CHANGE LIST

Model CT3/5 MB BOARD

CT3/5 MB
31CT3MB0015
31CT3MB0031

2A

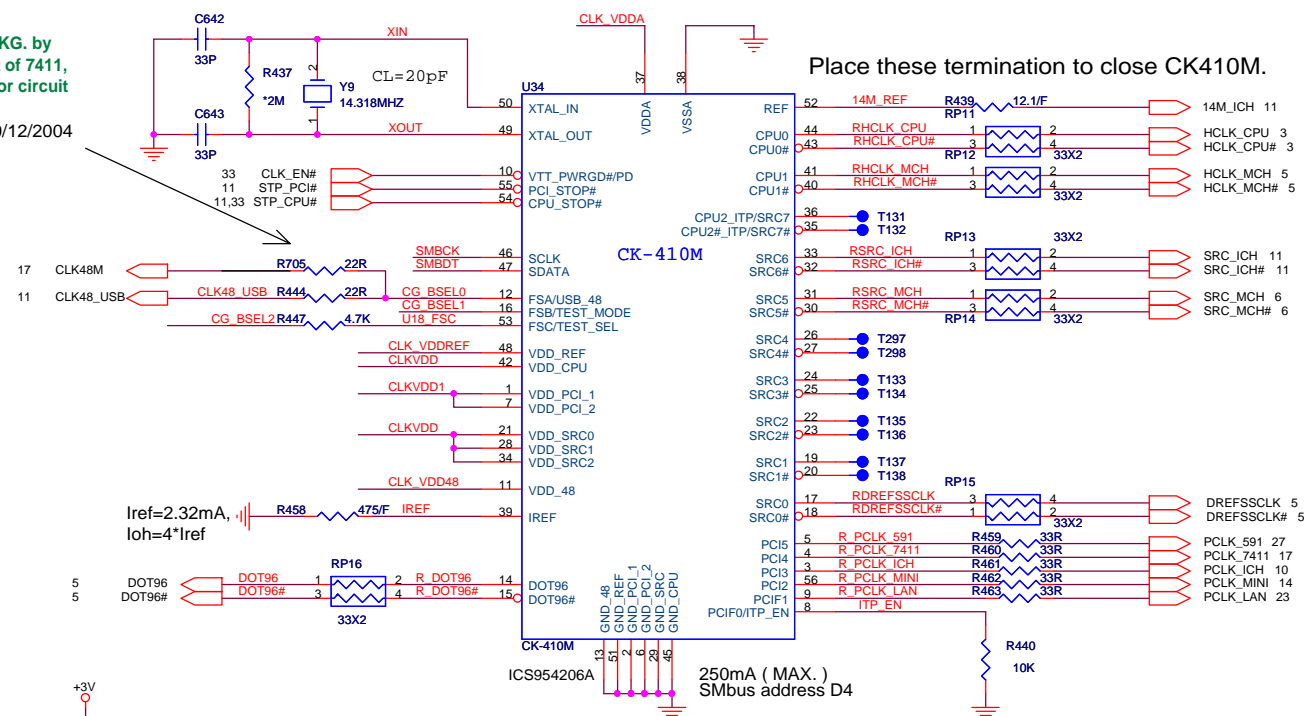
SI stage:
Enable CLK48M from CKG. by R705 for the PLL circuit of 7411, and disable the oscillator circuit at PCI7411 side.

PV stage:
Add C1048 for CLK48M to get better EMI performance.

CPU de-coupling capacitor

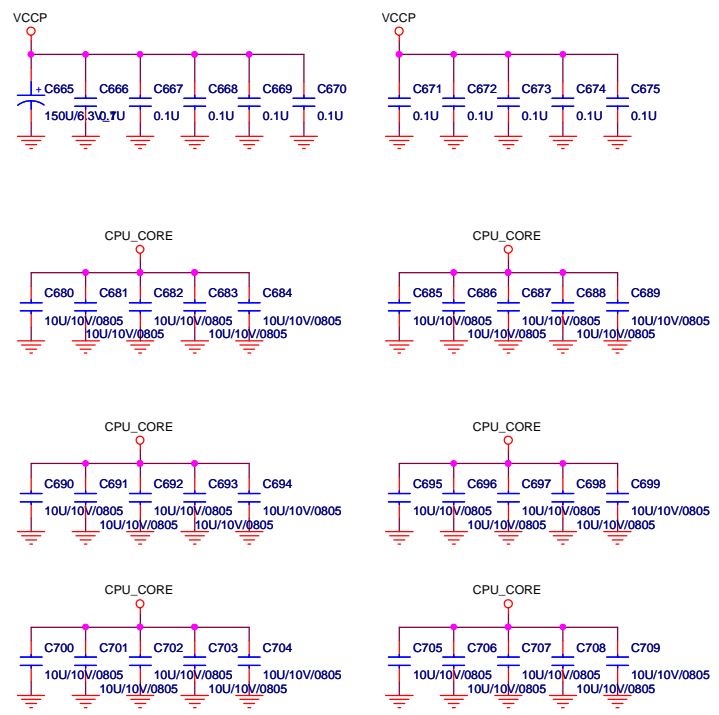
SI stage:
Use X7R type to replace Y5V type for Decoupling/Bypass capacitor.
Sting 10/12/2004

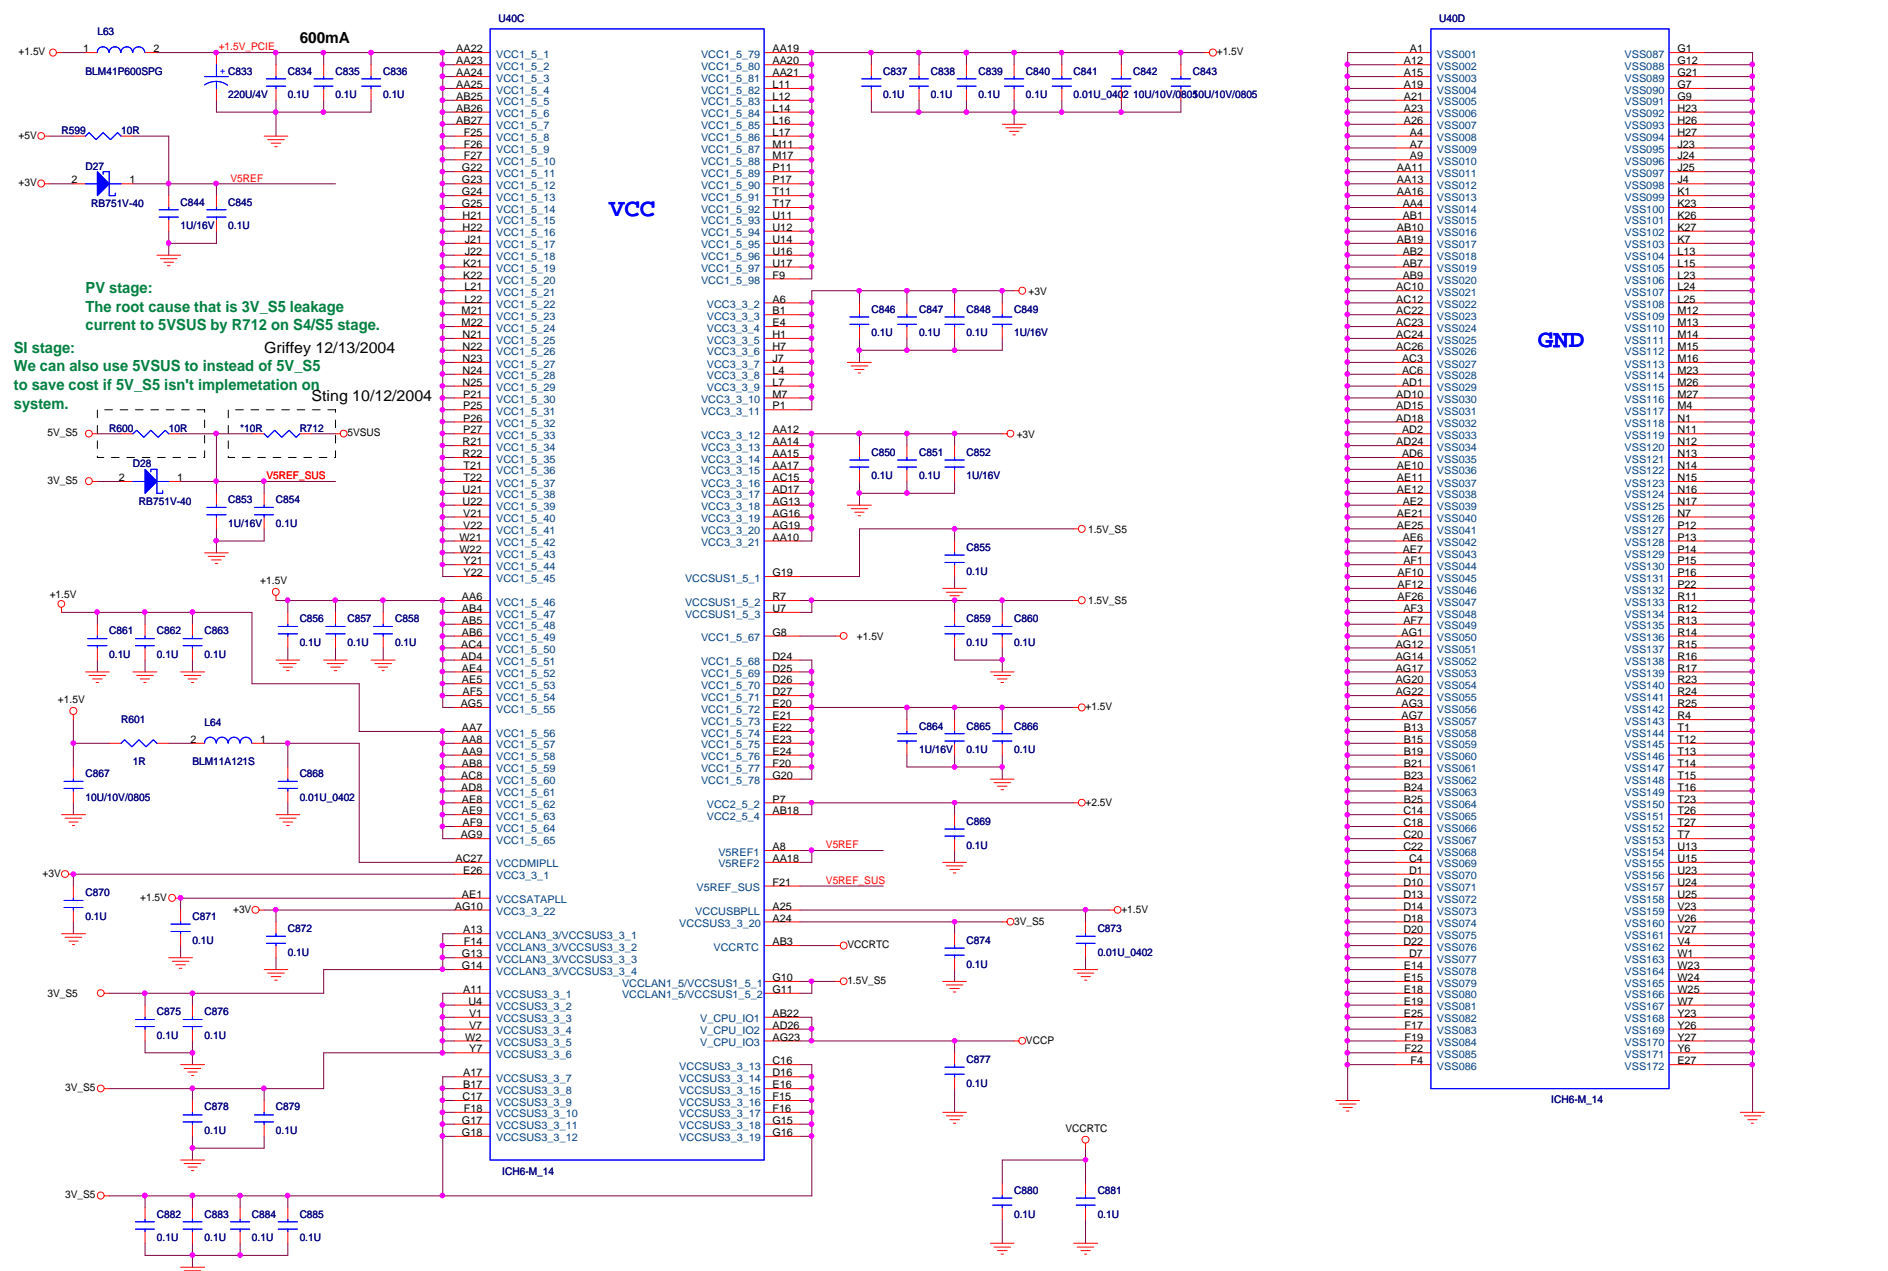
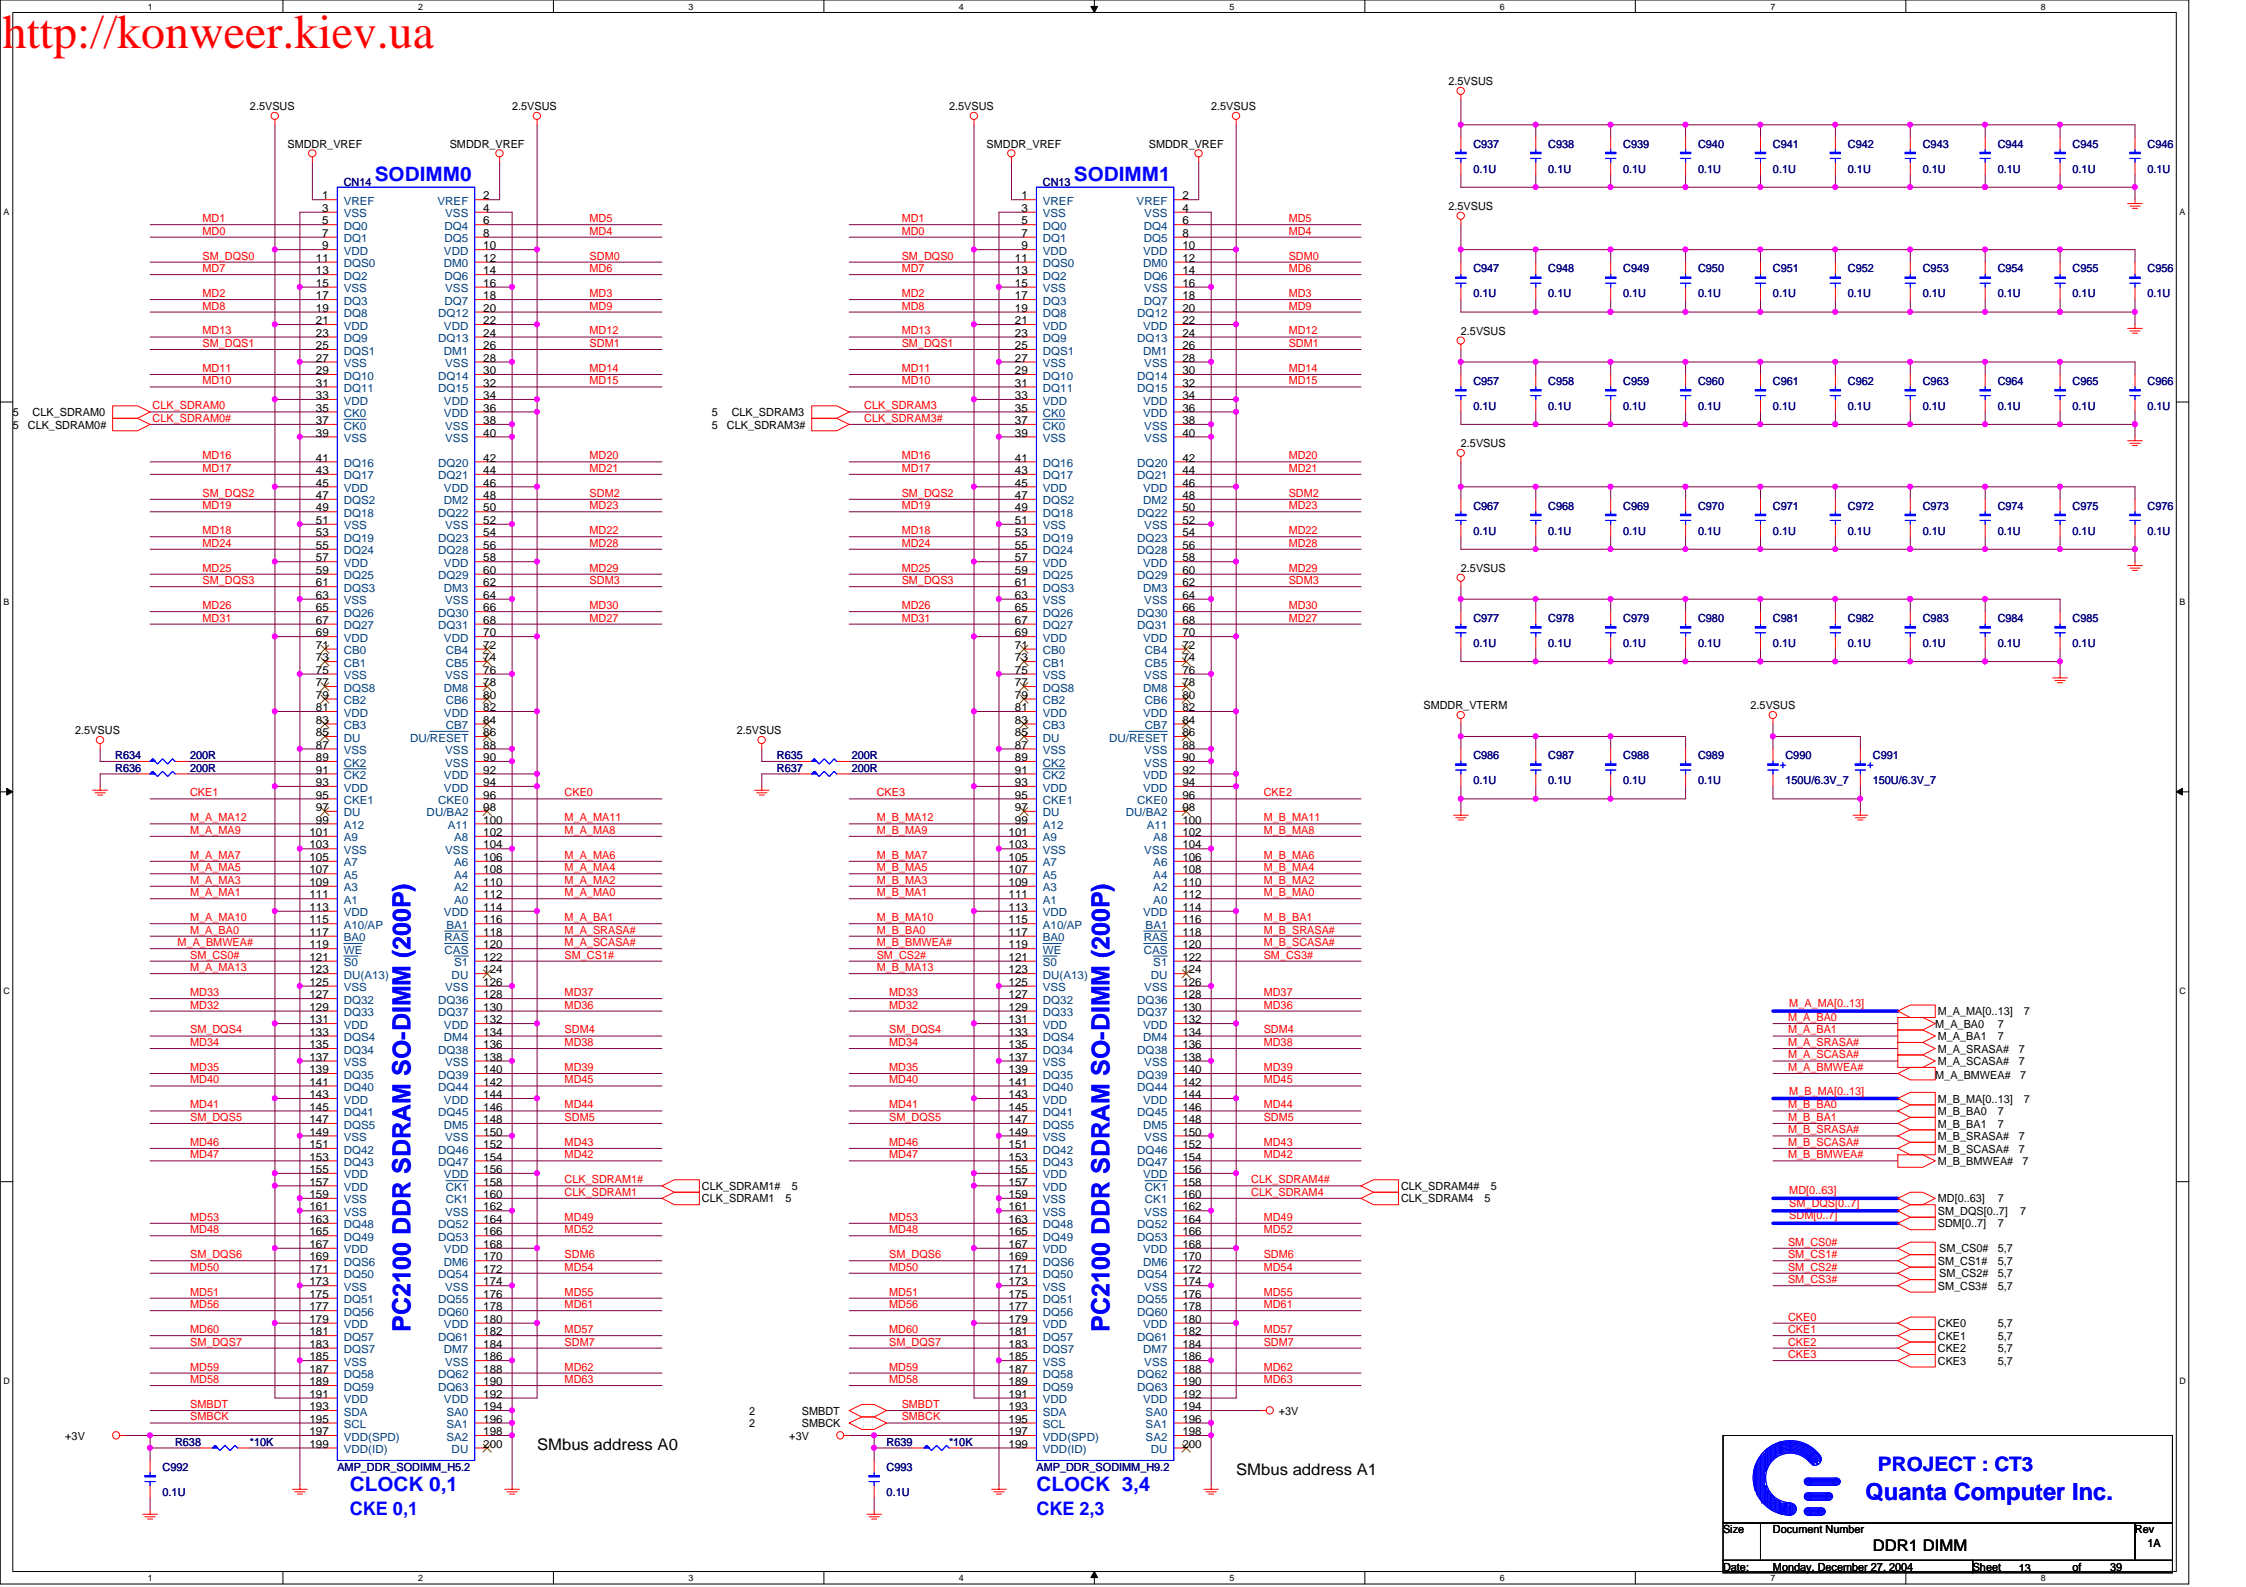
1. Change the power plane of PCIE_WAKE# from 3VSUS to 3V_S5 to solve system can't turn off issue.
2. Change the power plane of ICH_THRM# and SCTI_# from 3VSUS to +3V to solve leakage issue.
Sting 10/06/2004

SI stage:
R589 should be populated, because MCH_SYNC# is internally ANDed with PWROK.system will not booting without this pulled-up resistor.
Sting 09/24/2004

CARDBUS SLOT

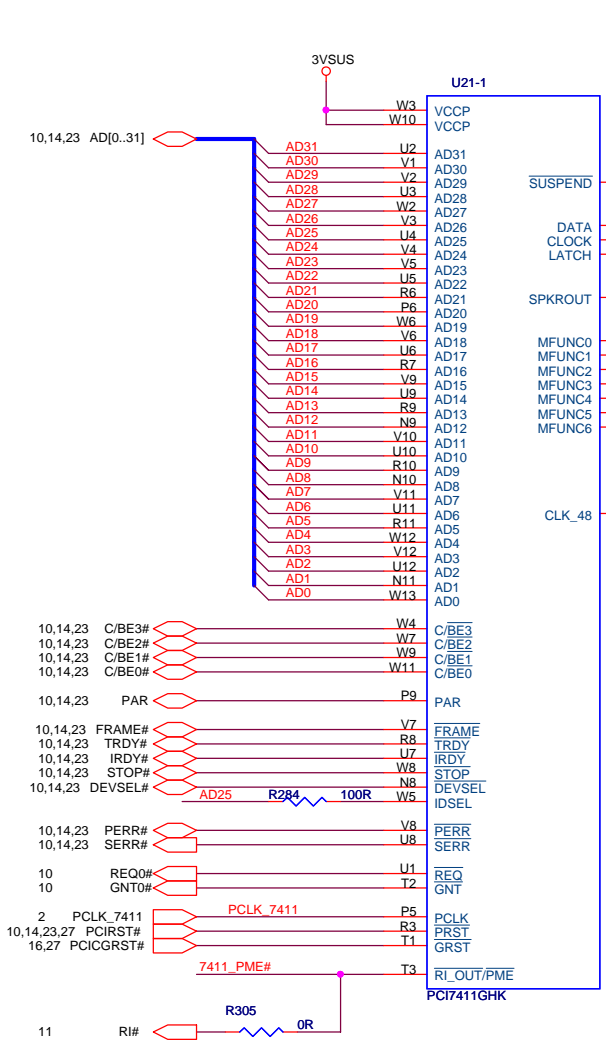
SI stage:
Remove reserve resistor R693~R695 for
PC11510RVGF
Sting 09/24/2004

PV stage:
Remove R701 & R702 for unused PCI1510RVGF
circuit.
Griffey 12/10/2004

5 IN1 CARD READER

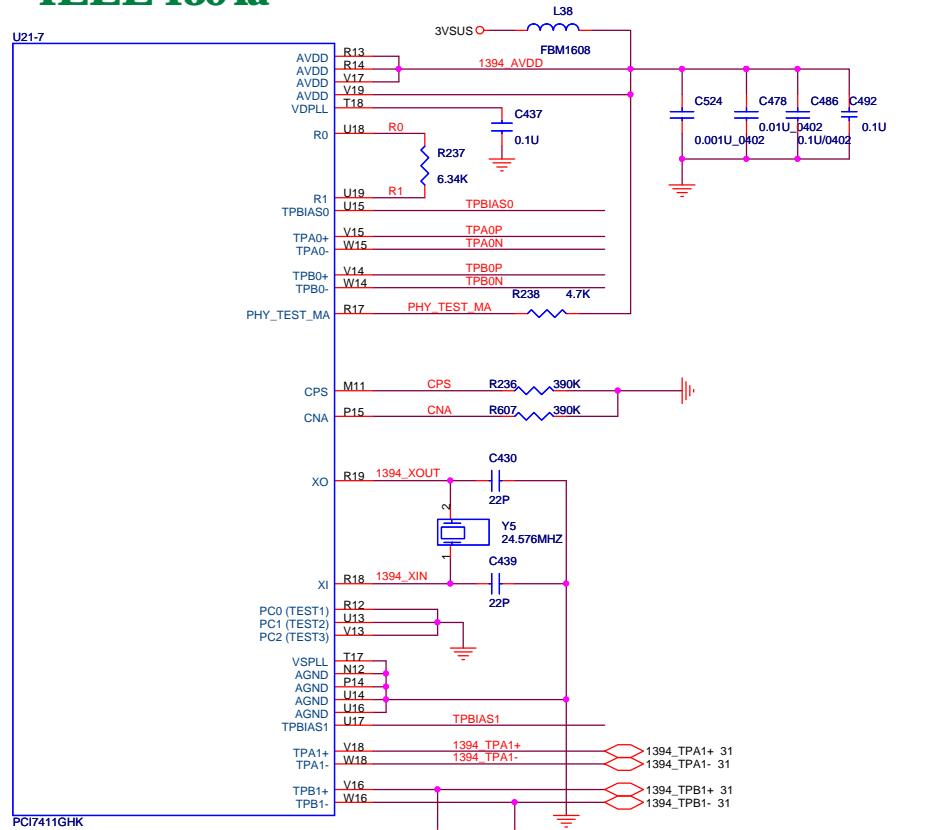
PV stage:
1. Add R717 to solve SM card can't write protect issue.
2. Add R718 to solve cross-talk issue of MS-PRO card.
3. Add R719-R736 as terminal on all multi-funtion pin.
Sting 11/19/2004

IEEE 1394 CONNECTOR

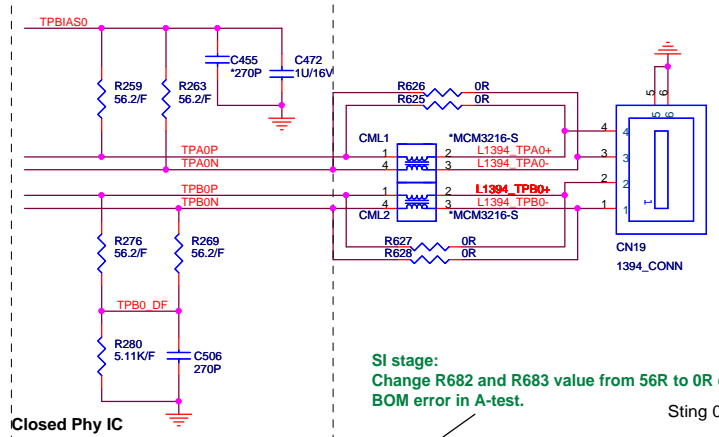
SI stage:
Change R682 and R683 value from 56R to 0R cause of BOM error in A-test.

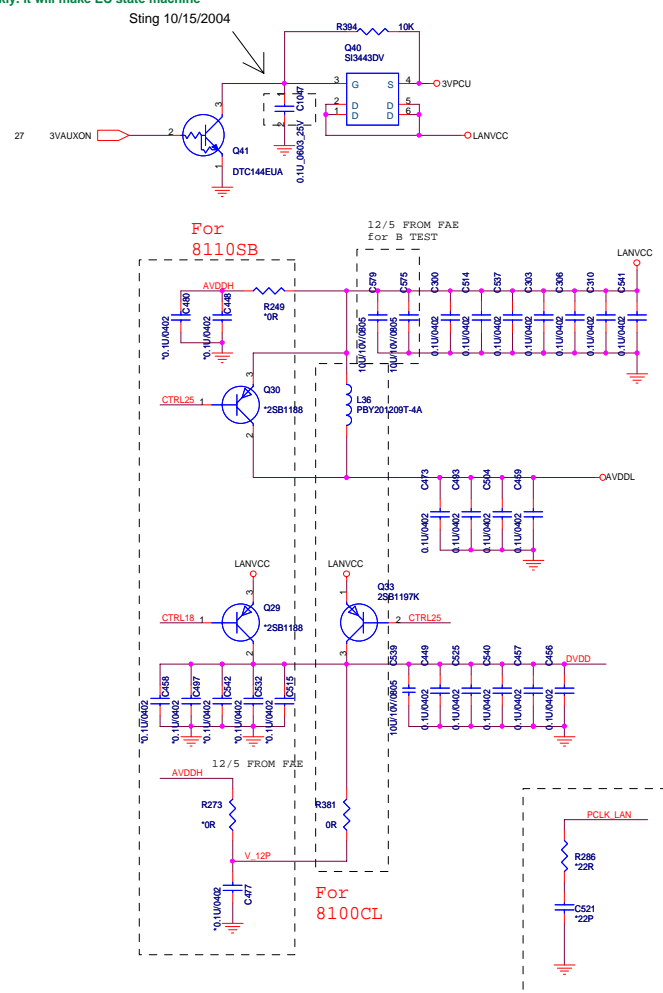
SI stage:
Add a 0.1uF to make Q40 turn on slowly, because 3VPCU will drop when LANVCC turned on quickly. it will make EC state machine crazy.

SI stage:
Add R707 for ID selection of Lan controller.

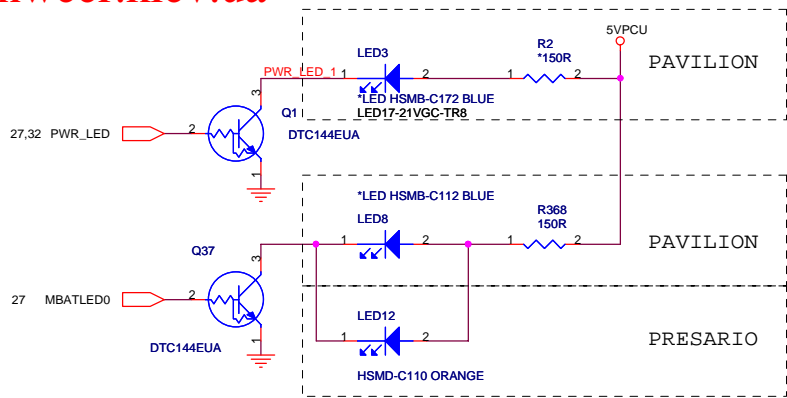
SI stage:
Modified transformer circuit for 10/100M application.
Sting 09/24/2004

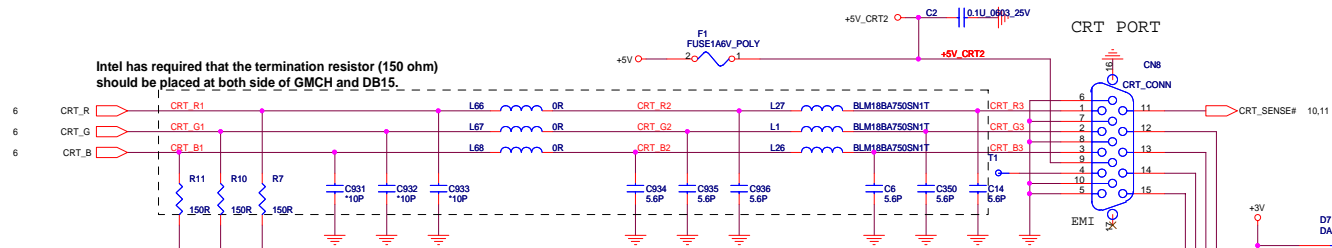
Intel has required that the termination resistor (150 ohm) should be placed at both side of GMCH and DB15.

PV stage: Adjust Capacitors and Bead to improve CRT timing issue.

1. Change L66, L67, L68 from BK1608HM470 to 0R.

2. Remove C931, C932, C933.

3. Change C934, C935, C936 from 22P to 5.6P.

4. Change C6, C14, C350 from 10P to 5.6P.

5. Change L1, L26, L27 from BK1608HM470 to BLM18BA750SN1T.
